Limit Shaft Speed-up on Field Modifications

MODKIT112A (for MTH/MTBH)

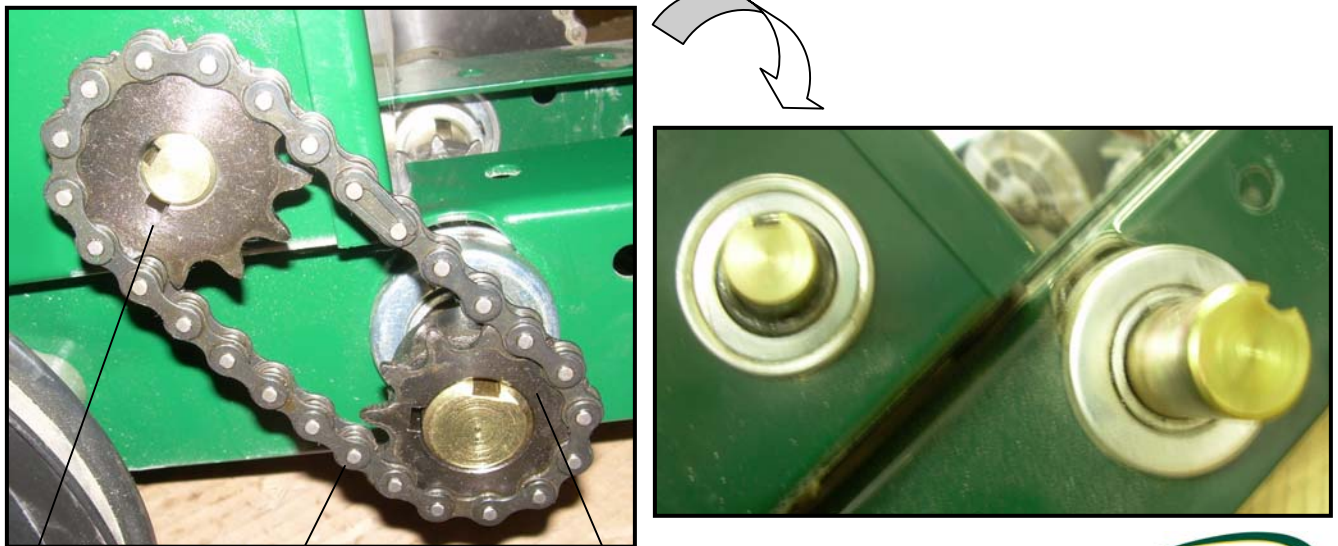
Step 1: Remove the limit shaft & chain and the drive sprocket from drive shaft.

Step 2: Mount speed-up sprockets and limit chain.
